Reviewers' Comments:

Journal: Nature Communications

Manuscript ID: NCOMMS-18-01336

Title: 2D perovskite stabilized phase-pure formamidinium perovskite solar cells

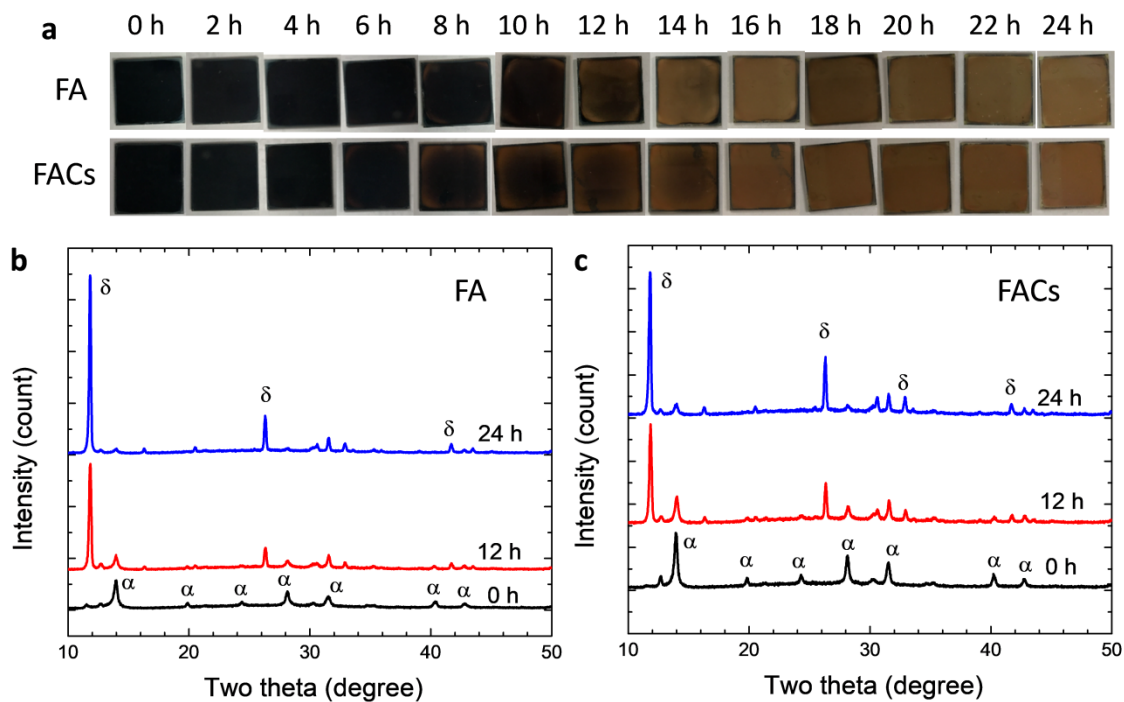
2. Adding Cs⁺ into FAPbI₃ to stabilize the black phase has already been revealed by Snaith (DOI: 10.1126/science.aad5845) and Graztel groups (DOI: 10.1039/C5EE03874J). It is important that the authors present a strong science argument with well supported data.

Ans) We appreciate the comments by the reviewer. As the reviewer pointed out, the stabilization of the black phase of formamidinium perovskite has been previously reported by several groups (N.-G. Park et al. *Adv. Energy Mater.* 2015, 5, 1501310. H. J. Snaith et al, *Science*, 2016, 351, 151. M. Graztel et al. *Energy Environ. Sci.* 2016, 9, 1989.) Typically, at least 10 mol% replacement of FA with Cs (5 mol% in combination with 17 mol% of MA) is required to stabilize the black perovskite phase in case of pure FAPbI₃. As mentioned in our original manuscript and supplementary information, we tried to minimize the incorporation of smaller ions such as Cs⁺, MA⁺, Br⁻ to maintain the low bandgap of pure FAPbI₃ perovskite. Indeed, we showed that replacement of 2 mol% of FA⁺ with Cs⁺ does not have significant impacts on the absorption onset of the perovskite films (**Supplementary Figure 9** and **note 2**). Also, the film without 2 mol% Cs but with 1.67 mol% of 2D perovskite was also stable under relative humidity of 80±5% for 24 h as seen in **Figure 3a** and **b**. We believe that the 2 mol% replacement of FA with Cs reduces the defect density as observed from time-resolved photoluminescence in **Figure 2**, but it does not play another critical role in our system.

For example, we compared phase-stability of the FAPbI₃ and FA_{0.98}Cs_{0.02}PbI₃ perovskite film under a relative humidity of 70±5% (**Figure R1**). As can be seen in the photos and X-ray diffraction (XRD) patterns of the films, both of FAPbI₃ and FA_{0.98}Cs_{0.02}PbI₃ perovskite films rapidly degraded within 24 h. The black color of the films were rapidly changed to yellow, which can be attributed to conversion of the cubic perovskite phase to yellow hexagonal non-perovskite phase. Therefore, we concluded that the significantly improved phase-stability is mainly owed to the added 2D perovskite.

Figure R4 | Schematic band diagram for FAPbI₃ perovskite films with different amount of added 2D PEA₂PbI₄ perovskite. **a**, smaller amount (<10 mol%) and **b**, higher amount (>10 mol%)

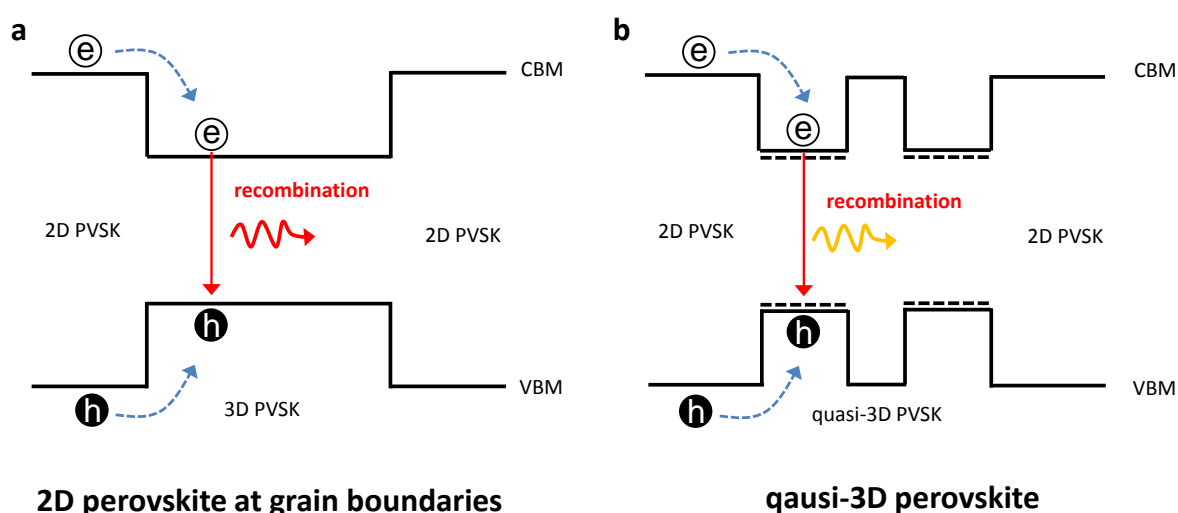
4. It is hard to draw a solid conclusion on the 2D perovskite by merely judging the PL spectra as charge transfer may occur between the 2D and 3D perovskite. Authors need to provide absorption spectra as well as other data to support their conclusions.

Ans) We thank the reviewer for the comment. As the reviewer pointed out, there will be a charge transfer between the 2D and 3D perovskites. Identical steady-state photoluminescence (PL) spectra with addition of 2D perovskite less than 10 mol% indicates the presence of pure 3D perovskite phase in terms of its density of states (DOS, **Figure R4**), so we speculate that the 2D and 3D perovskite do not form a mixed phase (quasi-3D perovskite) in consideration of XRD spectra showing pure cubic FAPbI_3 phase. When the amount of added 2D perovskite is 10 mol%, the steady-state PL spectrum shifted towards a shorter wavelength, indicating that the DOS of the lowest energy state (3D perovskite) is affected by the added 2D perovskite. We believe this evidences the formation of quasi-3D perovskite in which 2D perovskite is intercalated into the bulk of 3D perovskite to induce the charge carrier confinement and thus increased bandgap (**Figure R4b**). This speculation is well-correlated with additional XRD peak appearing at the low angle region (**Supplementary Fig. 4f**), which typically originates from the formation of quasi-3D perovskites.² Also, significantly reduced PL lifetimes in **Supplementary Fig. 13** indicate the possible charge carrier confinement effect by the 2D perovskite.

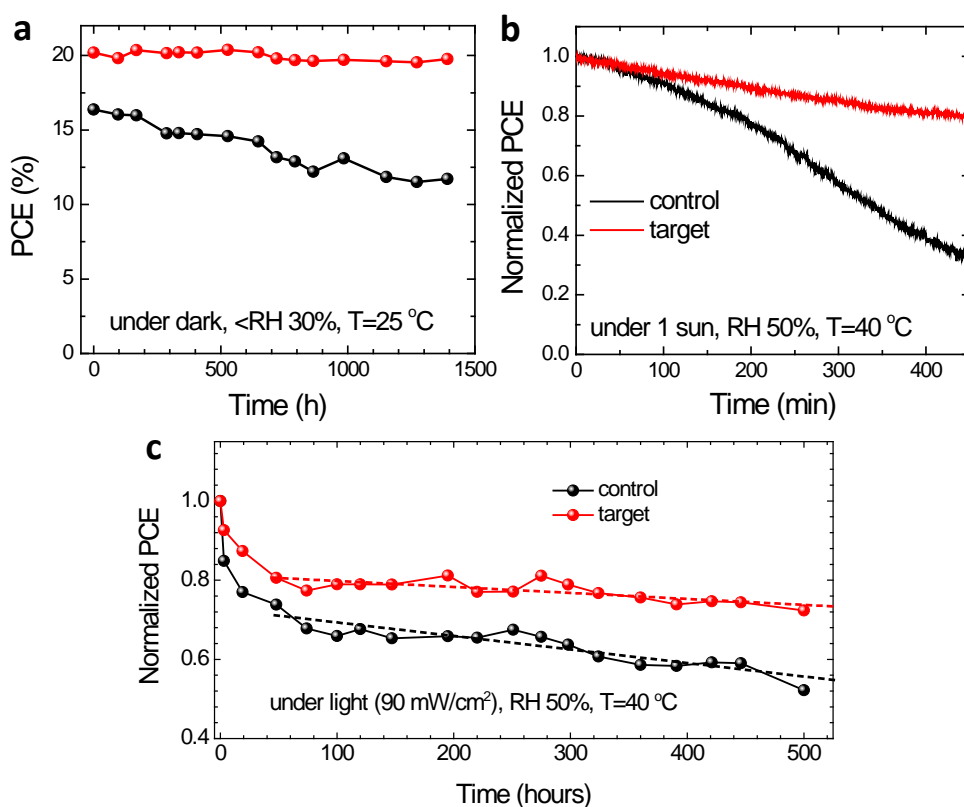
5. The moisture stability is tested under only 30% relative humidity and the operational stability is done for only 450 min. More rigorous stability test, e.g. 85% relative humidity and/or 1000 hour operational stability would improve the quality of the paper.

To address the reviewer`s comment, we performed 500 h of light exposure test with the encapsulated control (bare FAPbI₃ device) and target devices (w/ 1.67 mol% 2D PVSK). The encapsulated devices were exposed to ca. 0.9 sun (90±10 mW/cm²) under open-circuit condition, of which steady-state PCE was periodically measured with different exposure time. As seen in **Figure R6c**, both of the devices showed rapid initial decay in PCEs followed by slower decay with almost linear profile, which is in agreement with previous reports.³ After 500 h of exposure, the control device was degraded to ca. 52.3% of initial PCE whereas target device maintained 72.3% of the initial PCE, indicating enhanced stability with addition of 2D perovskite. Although we could not performed longer exposure test due to limitation in our lamp lifespan, we could extract tentative T80 (time at which PCE of the device decays to 80% of initial PCE) for the devices by fitting of post-burn-in region in which PCE of the device shows almost linear decay profile (after 48 h). The T80 for control and target devices were calculated to be 592 h and 1362 h, respectively. The T80 of the devices were enhanced more than two times by incorporating the 2D perovskite.

Figure 5 in original manuscript was replaced with **Figure R6**, and following sentences were added to the revised manuscript in page 11. “We performed 500 h of light exposure test with the encapsulated control (bare FAPbI_3 device) and target devices (w/ 1.67 mol% 2D PVSK). The encapsulated devices were exposed to ca. 0.9 sun ($90 \pm 10\text{ mW/cm}^2$) under open-circuit condition, of which the steady-state PCE was periodically measured for different exposure time. As seen in **Figure 5c**, both of the devices showed a rapid initial decay in PCE followed by slower decay with an almost linear profile, which is in agreement with previous reports.³ After 500 h of exposure, the control device degraded to ca. 52.3% of its initial PCE whereas the target device maintained 72.3% of the initial PCE, indicating enhanced stability with addition of 2D PVSK. We could extract tentative T80 (time at which PCE of the device

Figure R8 | Temperature-dependent conductivity of **a**, bare FAPbI₃ film and **c**, with 1.67 mol% 2D PEA₂PbI₄ perovskite. Current-voltage curves measured from the devices at 180 K. **c**, bare FAPbI₃ film and **d**, with 1.67 mol% 2D PEA₂PbI₄ perovskite.

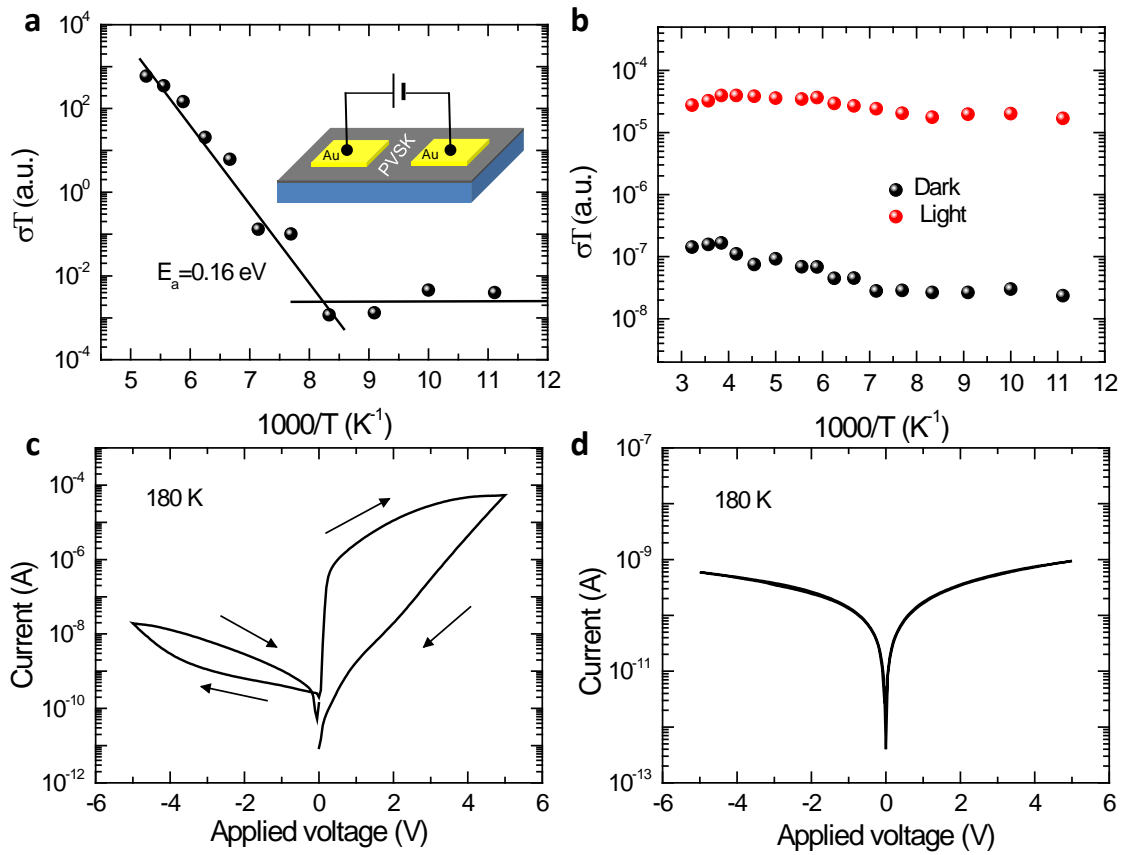
2. The observation of suppressed ion migration with 2D perovskite is very important. Maybe adding this in the main text? Also, does the improved phase purity have any impact on the reduced ion migration?

Under operational condition with abundant photo-generated charges and built-in electric field, the major factors causing the degradation of the devices might be the highly mobile and reactive charged defects (ions) and/or trapped charge carriers associated with it.^{3,5} We suppose that migration of the charged defects or ions is possibly suppressed by 2D perovskite at grain boundaries. We performed temperature-dependent conductivity (σ) measurement of the lateral devices (inset of **Figure R8** describes the structure of the devices) to evaluate the activation energy for ion migration (**Figure R8**). The activation energy (E_a) for the migration can be determined according to the Nernst-Einstein relation:³

where k is Boltzmann constant, σ_0 is a constant. With bare FAPbI₃ perovskite, exponential enhancement in conductivity was clearly identified at around 130 K (**Figure R8a**), which is attributed to contribution of ions. The E_a for bare FAPbI₃ film was calculated to be 0.16 eV, indicating significant contribution of activated ions at room temperature, which might cause degradation of the material and device under operational condition with built-in electric field. The pronounced current-voltage hysteresis behavior was observed even at very low temperature (180 K, **Figure R8c**). For addition of 2D perovskite, the film did not show noticeable enhancement in conductivity with increased temperature although the overall conductivity was relatively lower than the bare FAPbI₃ film (**Figure R8c**). Even with moderate light illumination, it does not show indication of activated ions. As a result, the current-voltage curve did not show any hysteresis behavior (**Figure R8d**). We believe the suppressed ion migration contributes to enhanced operational stability of the target device.

Ans) We thank the reviewer's suggestion. According to the suggestion, we have added the temperature-dependent conductivity measurement in the main text as **Figure 6**. We think that passivation of grain boundaries by 2D perovskite mainly contributes to the suppressed ion migration. The grain boundaries of 3D perovskite were reported to be a major pathway for migration of ions,² passivating the grain boundaries by incorporation of the ion-migration-immune 2D PVSK likely suppressed overall ion migration in the target device.³ However, we do think that the improved phase purity of the film might also partially contribute to the suppressed ion migration because the secondary phase can generate defect sites that can act as an additional pathway for ion migration. We have added following discussion in page 13.

Figure R9 | X-ray diffraction patterns for MAPbI₃ perovskite films without and with 1.67 mol% 2D PEA₂PbI₄ perovskite. **a**, full spectra and **b**, magnified (110) orientation peaks

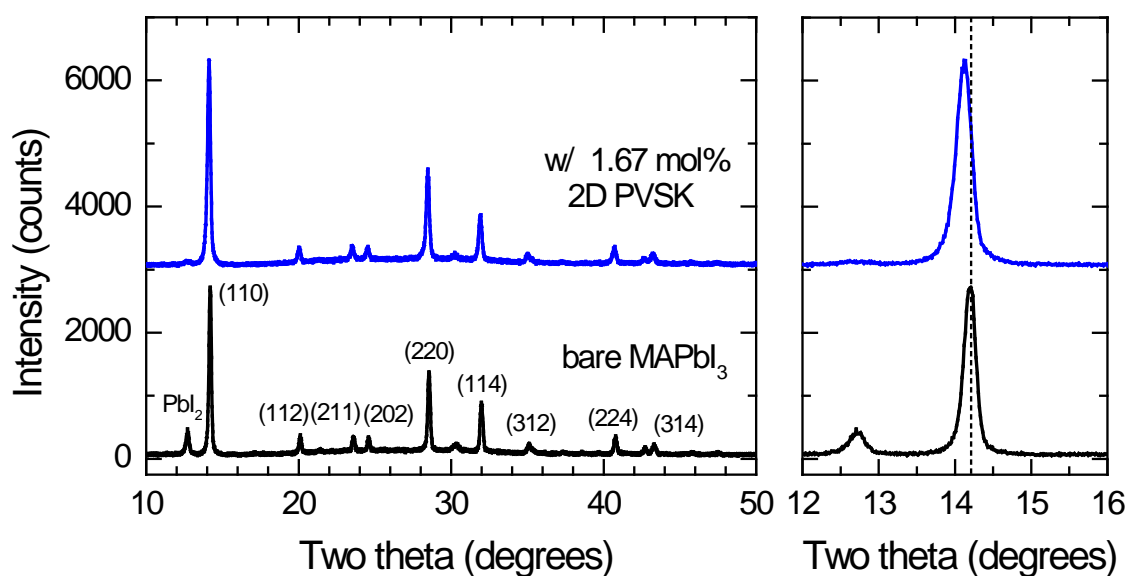
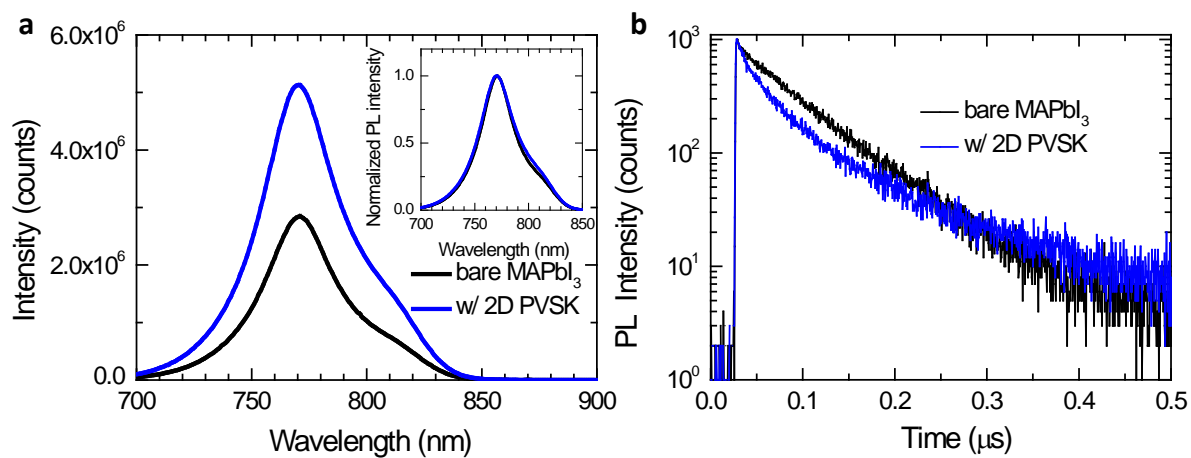
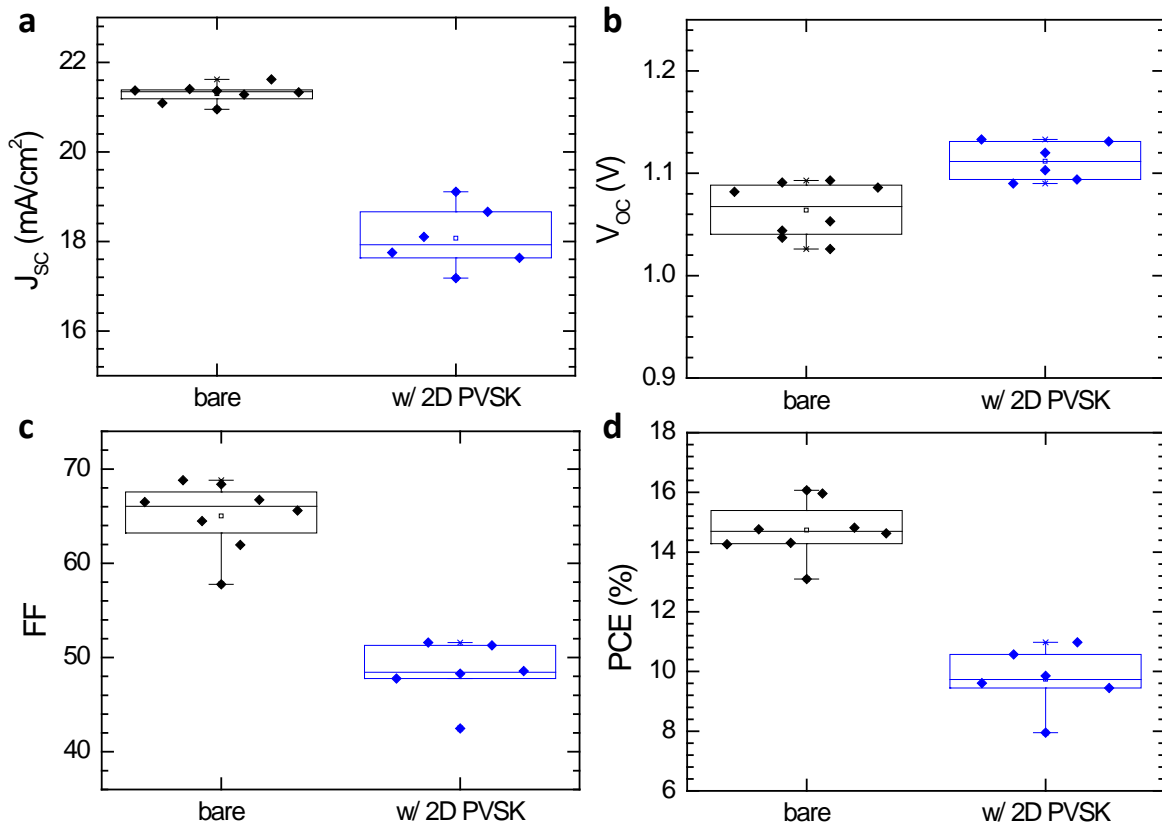
3. Both previous report of Nature Energy, 2017, 2, 17135 and this work show that the 2D perovskite could be vertically located at grain boundary of FAPbI₃ as Ruddlesden-Popper perovskite while it usually form a homologous 2D-3D perovskite in MAPbI₃ and it is so difficult to obtain such 2D Ruddlesden-Popper for MAPbI₃. Could the authors give more thorough discussion on the reason why there is such difference between FACs and MA cation based perovskite.

Ans) We thank the reviewer for pointing out the important aspects of 2D-3D perovskites. We also tried to incorporate the 2D PEA₂PbI₄ perovskite into the MAPbI₃ perovskite. We observed slight enhancement in peak intensity of X-ray diffraction pattern, and do not see any additional peaks from the XRD pattern as observed in FAPbI₃ perovskite (**Figure R9**). Also, the normalized PL spectra of the films were almost identical regardless of the added 2D PVSK (inset of **Figure R10a**). Therefore, we speculate that the added 2D PVSK is probably formed at the grain boundaries. However, we observed very different phenomena with the case of FAPbI₃ (or FACsPbI₃) perovskite. First, the diffraction peaks of MAPbI₃ films were shifted toward lower angle upon addition of 1.67 mol% 2D PEA₂PbI₄ perovskite, which is contrary to FAPbI₃ case (please see answer of question 2 by reviewer 1). Furthermore, while the steady-state PL intensity is increased with addition of 2D PVSK, the PL lifetime was decreased with 2D PVSK (61.1 ns for bare MAPbI₃ and 37.0 ns with 2D PVSK). We also fabricated the devices with bare MAPbI₃ and with 1.67 mol% 2D perovskite. However, all the photovoltaic parameters except open-circuit voltage (V_{OC}) were degraded with addition of 2D PVSK. We believe these are indicative of the different interactions between the MAPbI₃ and 2D PEA₂PbI₄ perovskite with those of FAPbI₃ case, probably in terms of crystallography, causing completely different effects on electronic properties. We could not find the possible explanation yet, but plan to perform more in-depth study on these aspects.

Figure R1. Absorption and normalized PL spectra of bare FAPbI₃ and FAPbI₃ with 1.67 mol% PEA₂PbI₄ 2D perovskite. Inset shows onset region of the absorption spectra with linear approximation.

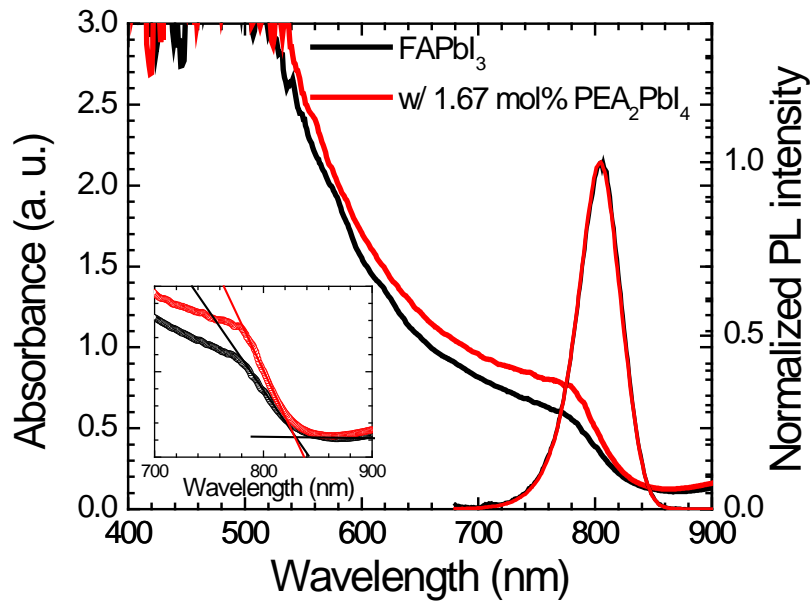
1. Why the enhanced phase purity would cause a red-shift in the absorption spectra, but no shift in the PL? What are the impurities/less-pure phases?

Ans) As we mentioned in our manuscript, absorption onset of pure FAPbI₃ and FAPbI₃ with 1.67 mol% 2D perovskite is actually same, which indicates bandgap is not affected by the added 2D perovskite, so the photoluminescence spectra are almost identical. We have added inset in **Figure 1c** to show onset region of the absorption spectra with linear approximation (see **Figure R1**).

As the reviewer pointed out, absorption of the FAPbI₃ film with addition of 1.67 mol% 2D perovskite was significantly enhanced (**Figure 1c**), which was attributed to the enhanced phase-purity. The presence of a secondary phase in the pure FAPbI₃ film was identified from X-ray diffraction pattern in **Figure 1b**, in which the hexagonal non-perovskite phase was indexed by δ . We already mentioned it in the manuscript with corresponding references (page 4, reference 29). In addition, the enhancement of absorption at longer wavelength region can be partially ascribed to an enhanced light scattering with larger grain size.¹ We have added the following discussion and reference in the revised manuscript page 5.

“The enhanced absorption as seen when the 2D PVSK was added is probably due to an enhanced phase purity of the FAPbI₃, with partial contribution from an enhanced light scattering owing to the improved crystallinity.¹”
